To: T10 Technical Committee  
 From: Steven Fairchild, HP ([steve.Fairchild@hp.com](mailto:steve.Fairchild@hp.com))  
 Date: 4 September 2003  
 Subject: SAS Discover Algorithm Modification

## Changes to correct the Discover process algorithm in Appendix J.

**Clarifying diagrams for the Discover process route table optimization.**

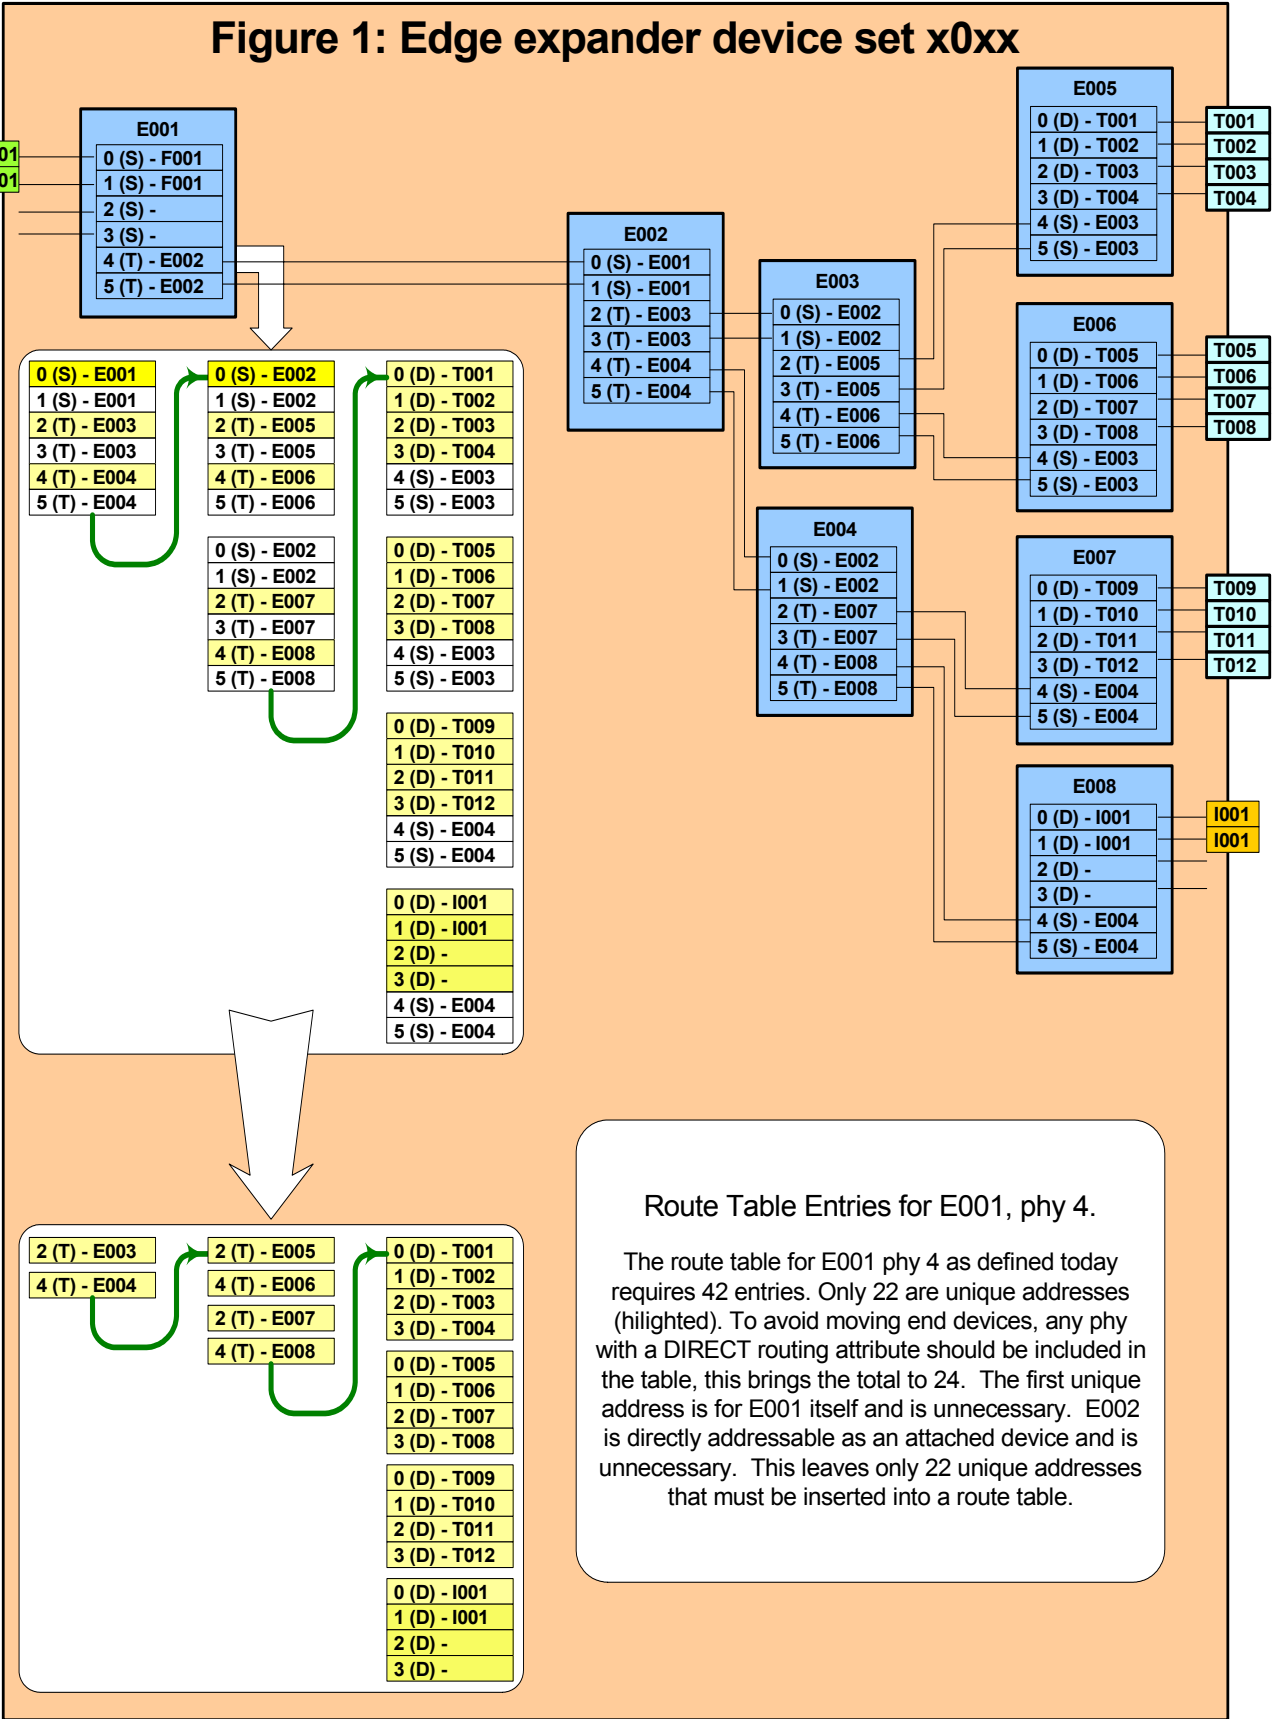
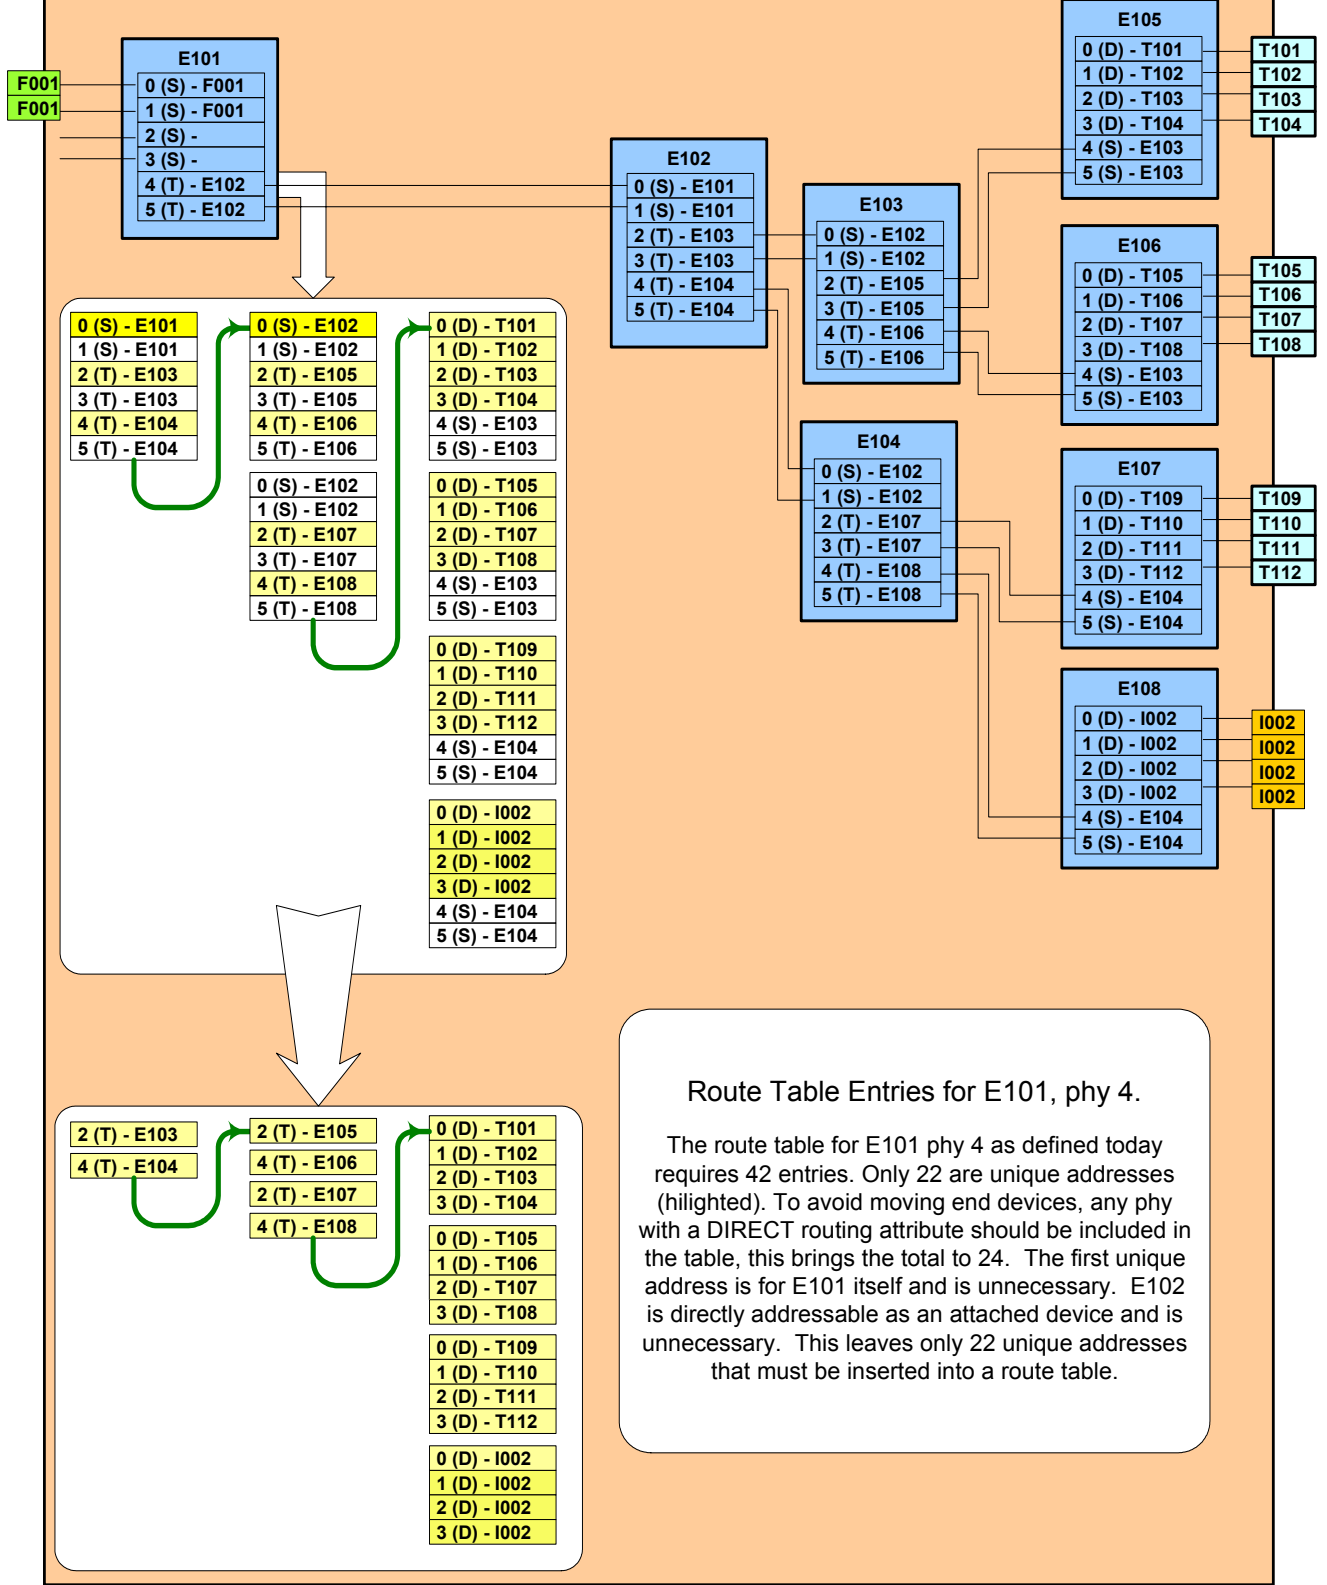
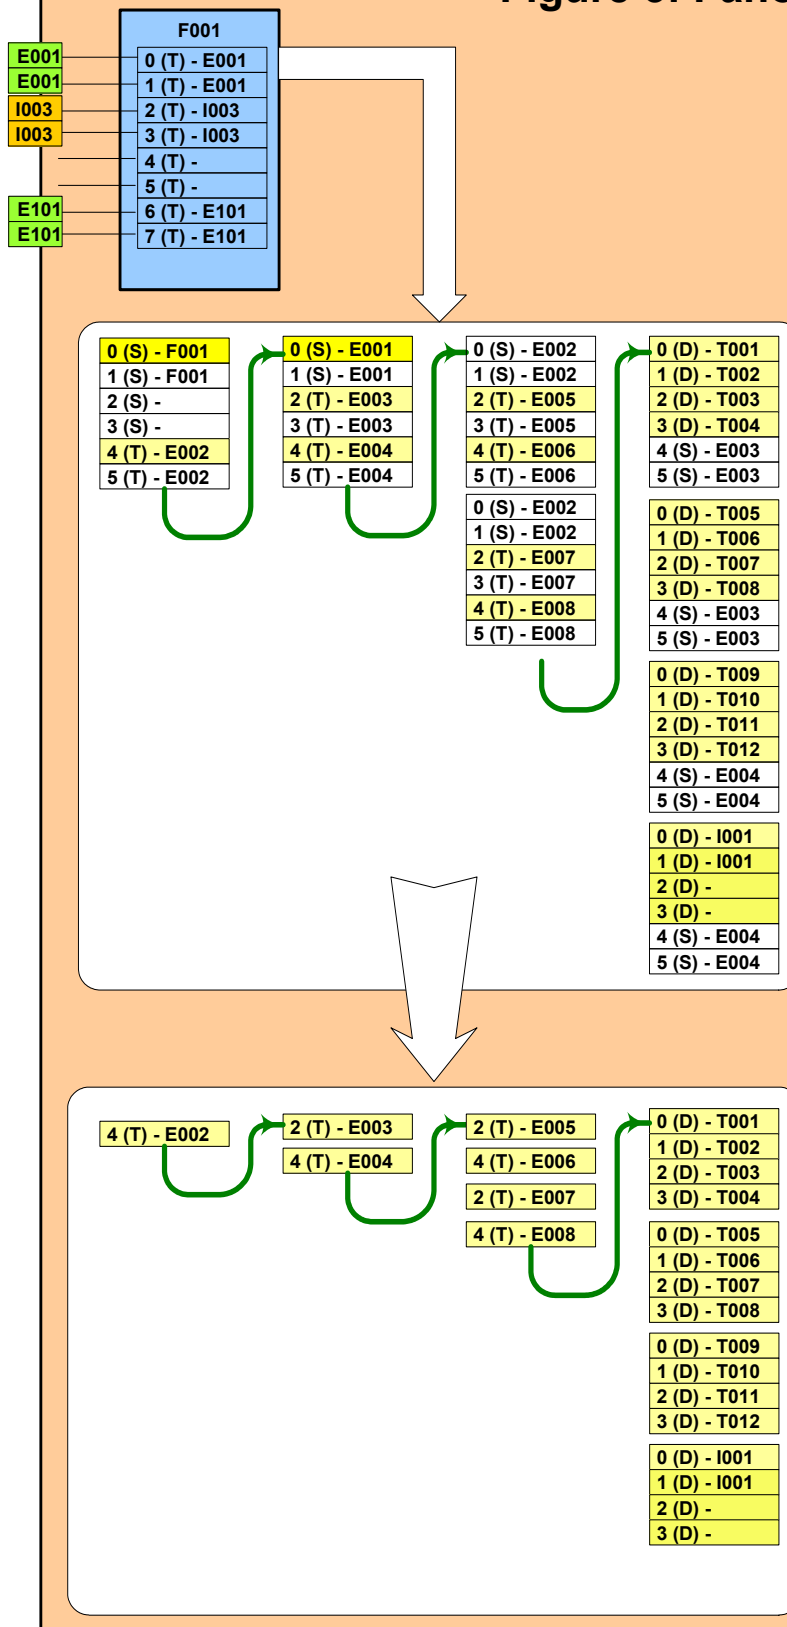
Figures 1, 2 and 3 describe a topology that has two, edge expander device sets connected with a fanout expander. Each figure shows the original route table contents and the optimized route table contents.

The route table for F001 phy 2 requires 48 entries. Only 22 are unique addresses (highlighted). To avoid moving end devices, any phy with a DIRECT routing attribute should be included in the table, this brings the total to 25. The first unique address is for F001 itself and is unnecessary. E001 is directly addressable as an attached device and is unnecessary. This leaves only 23 unique addresses that must be inserted into a route table.
